## Cardiff Replacement LDP Examination

Statement of Common  
Ground between Cardiff  
Council and Associated  
British Ports

### Boundary on Deposit Plan Proposals Map of allocations H2.4 and H2.5 and Policy SP9

**Proposed Revised Boundary on Proposals Map for allocation H2.5 (now H2.4 following deletion of H2.4) and Policy SP9**

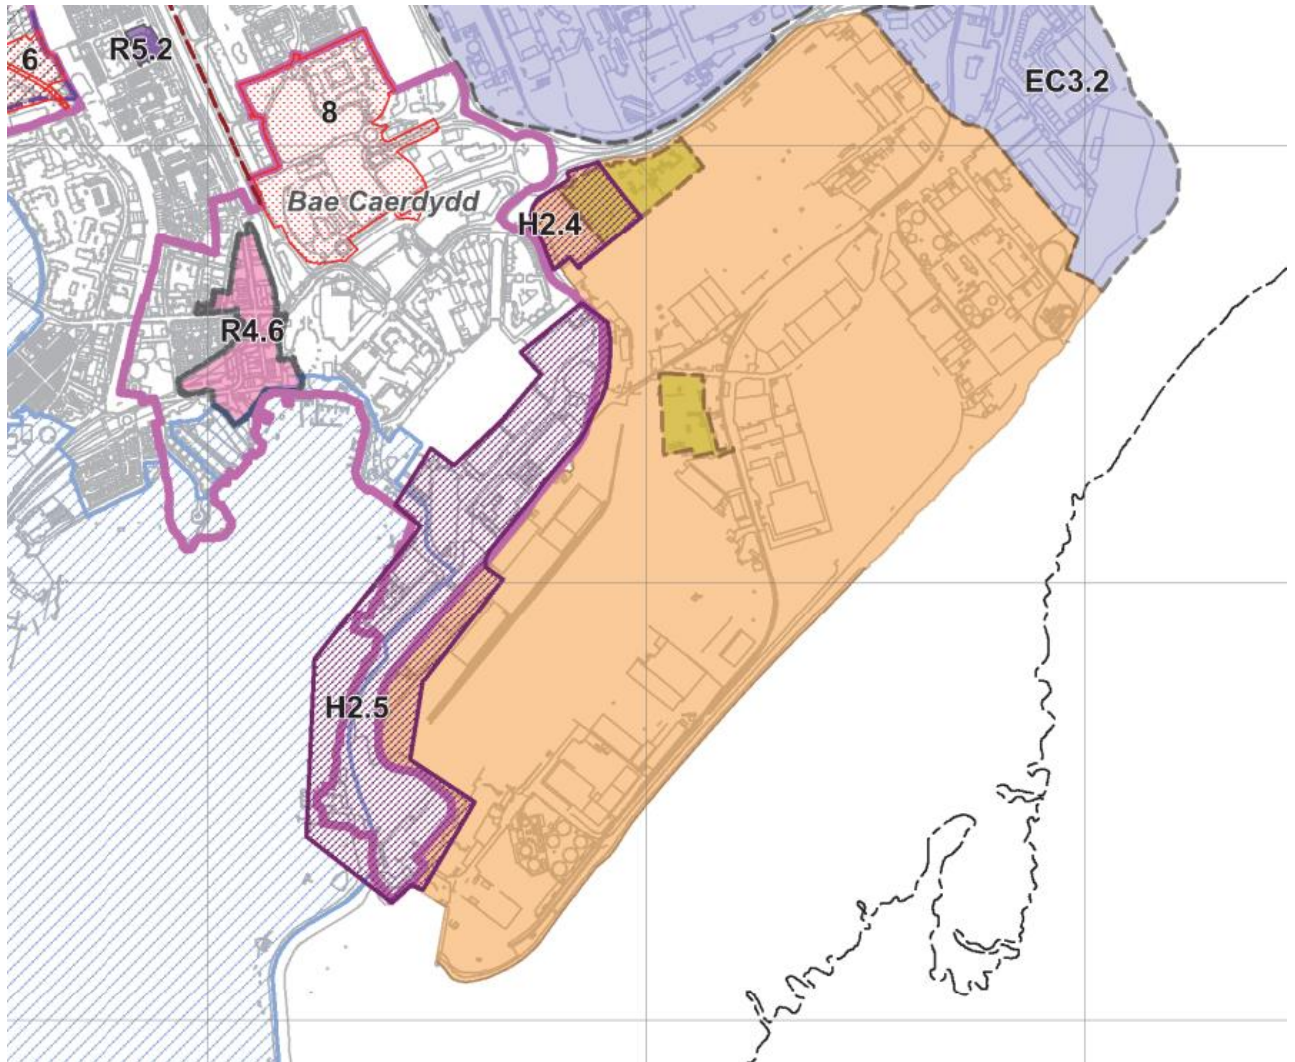
1.4 Firstly, ABP have objected to the boundary shown on the Proposals Map of the housing led regeneration area allocated under policy H2.5 at Porth Teigr and Alexandra Head boundary. ABP have requested that the boundary is redrawn to exclude land that falls with ABP ownership and buffer land immediately adjacent to the boundary of the operational port. (Representations 86.02 and 86.05).

- 1.9 Secondly, ABP have objected to the site allocation of housing led regeneration area H2.4 at Roath Dock (North Side) stating it is not deliverable and should be deleted from the plan given ABP as landowner have no intention to dispose of the land for housing in the plan period. ABP also state the allocation conflicts with policy MW6: Sand Wharf Protection Areas of the plan, the Regional Technical Statement 2<sup>nd</sup> Review (2020) and Planning Policy Wales (paragraph's 5.14.8 and 5.14.9) and would also introduce an incompatible development within the operational area of the docks (Representations 86.01 and 86.04).

1.5 The Council have undertaken a review of the boundary as requested by ABP and a revised boundary for the housing led regeneration area H2.5 at Porth Teigr and Alexandra Head has been agreed between the parties that excludes all land owned by ABP from the proposed designation. This is included at Appendix A to this statement and will also result in changes to the boundary shown on the Proposals Map for Policy SP9: Supporting the Role of Cardiff Port. It is proposed that these changes are included in the forthcoming Matters Arising Changes (MAC) consultation.

- 1.10 For the reasons set out above the Council agree with ABP that this allocation should be deleted from the plan, and it is proposed that policy H2: Housing Led Regeneration Areas is amended and allocation H2.4 Roath Dock (North Side) is deleted from the policy and deleted from the Proposals Map. It is proposed that these changes are included in the forthcoming Matters Arising Changes (MAC) consultation.
